STAFF REPORT

TO: Planning Commission
FROM: Ben Prchal, City Planner
AGENDA ITEM: The Legacy at North Star Third Addition – Easement Vacation(s) and Final Plat and PUD Plans
REVIEWED BY: Ken Roberts, Planning Director

To: Ken Roberts, Planning Director	Re: Legacy at Northstar 3rd Addition – Final Plat
Cc: Chad Isakson, P.E., Assistant City Engineer	Engineering Review Comments
From: Jack Griffin, P.E., City Engineer

To: Ken Roberts, City of Lake Elmo Planning Director
From: Lucius Jonett, Wenck Landscape Architect
Date: February 19, 2020
Subject: City of Lake Elmo Landscape Plan Review
Legacy at Northstar 3rd Addition, Review #1

LEGACY AT NORTH STAR 3RD ADDITION

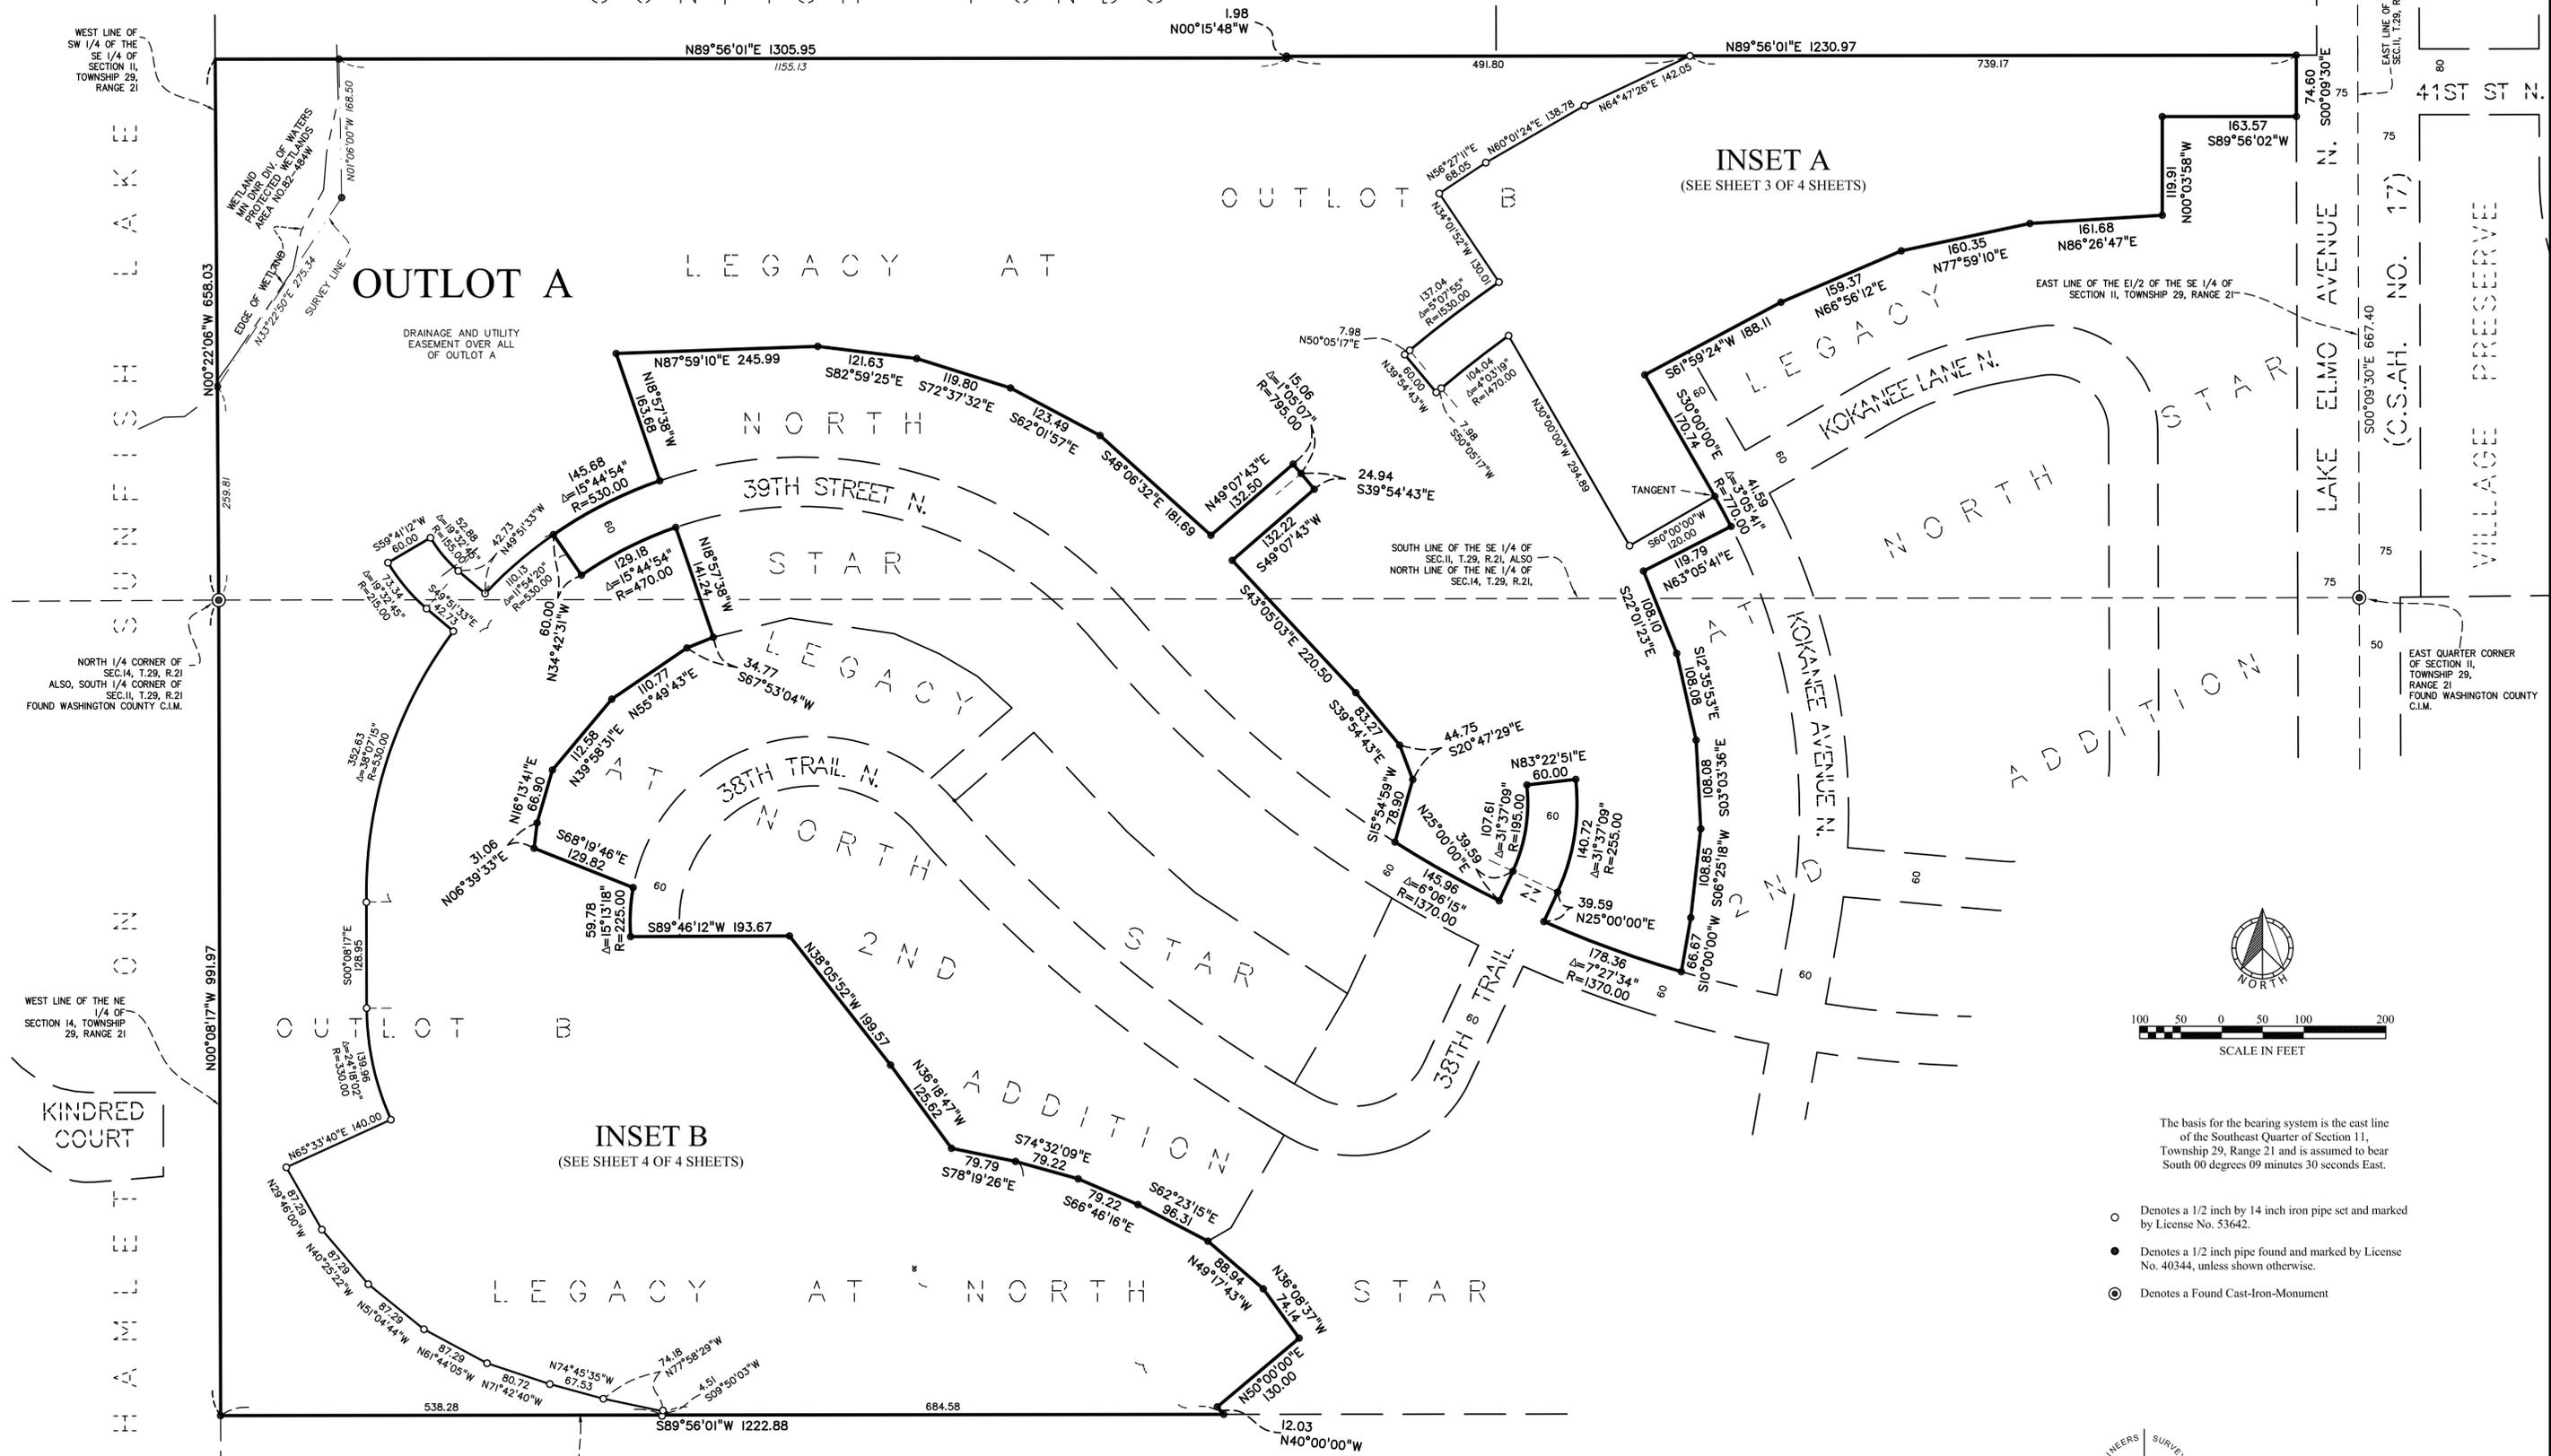
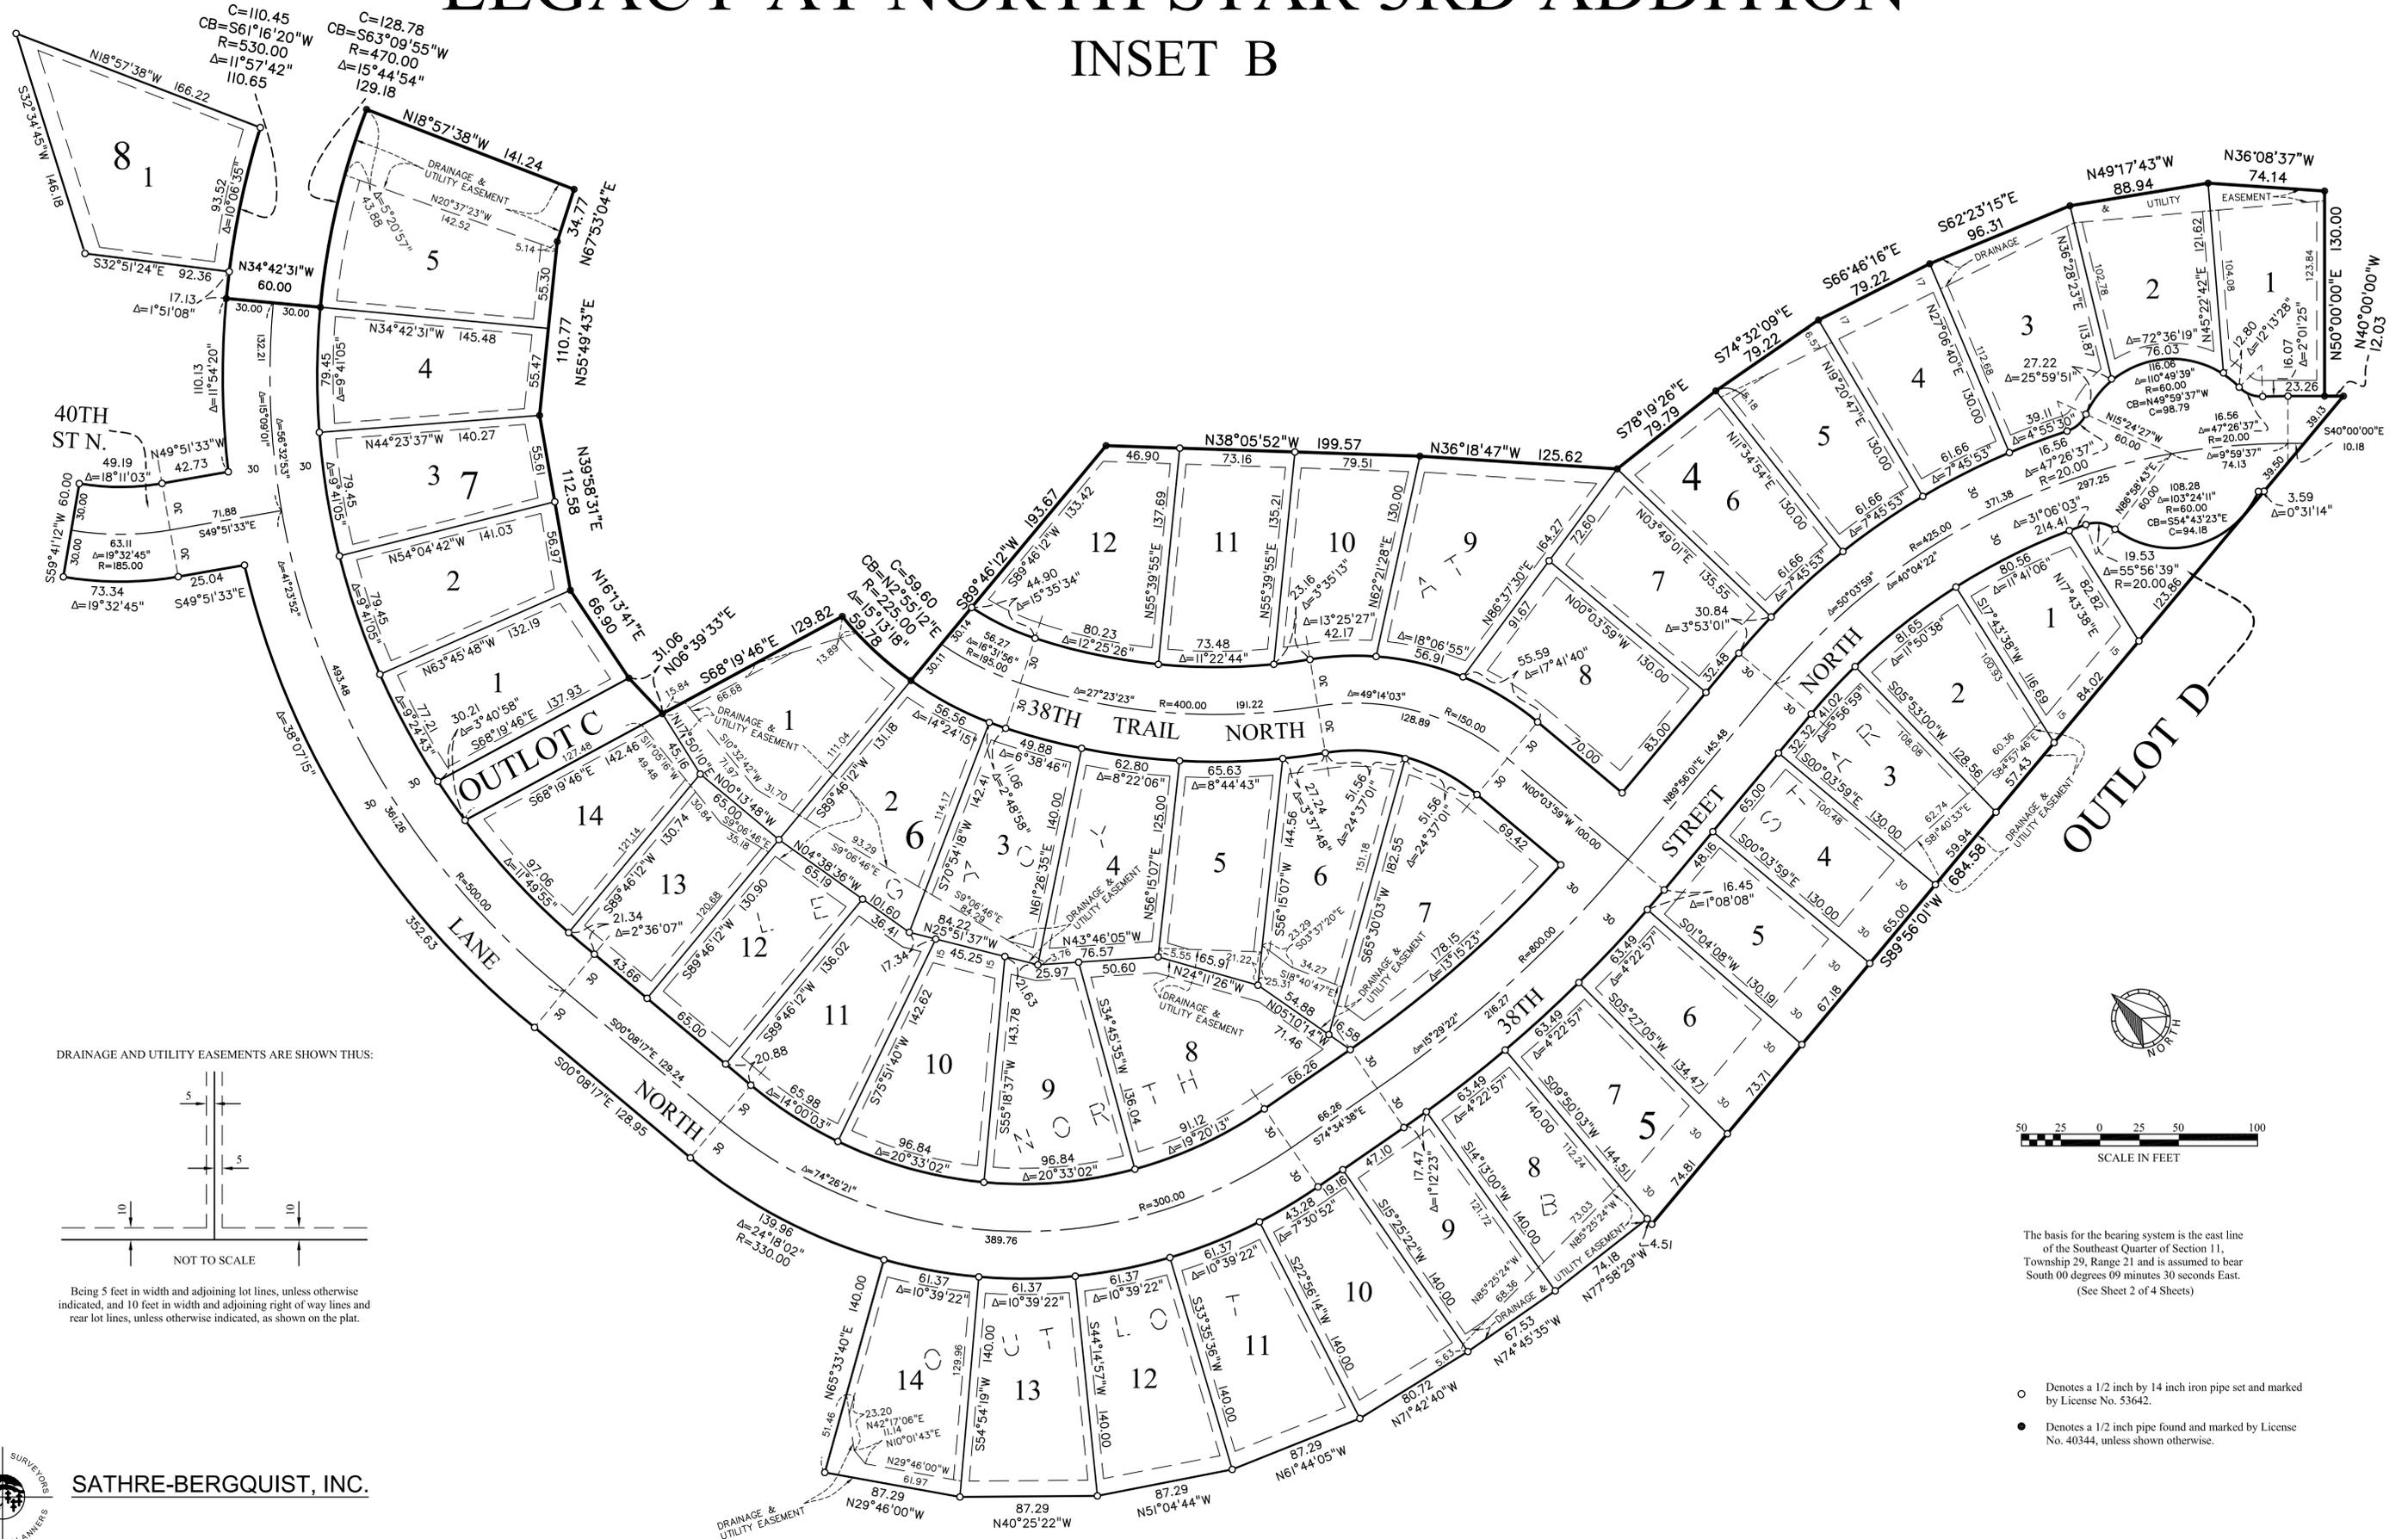
- The Final Plat should be revised to either remove Lot 1, Block 8 (to be constructed with future development phases) or to include the dedication of Outlot J (HOA owned) with a drainage and utility easement to the city over the entire Outlot.

- The Final Plat/construction plans must include a temporary cul-de-sac on the west end of 41st Street in order to include Lots 1 and 2, Block 3 as platted lots in the 3rd Addition.

- Outlot A is shown as Shiltgen Family owned and is reserved for future development.
- Outlot B is shown as HOA owned as required. The Final Plat must be revised to add a drainage and utility easement over all of Outlot B.

- Outlot C is shown as HOA owned as required. The Final Plat must be revised to add a drainage and utility easement over all of Outlot C.

- Outlot D is shown as HOA owned. The Final Plat must be revised to add a drainage and utility easement over all of Outlot D. The approved preliminary plat shows Outlot D as developer owned?

- The Final Plat and Final Construction Plans must be revised so that Outlots and ownership are consistent throughout the Final Plat and Final Construction Plans. There are significant discrepancies between the proposed final plat and proposed plan documents.
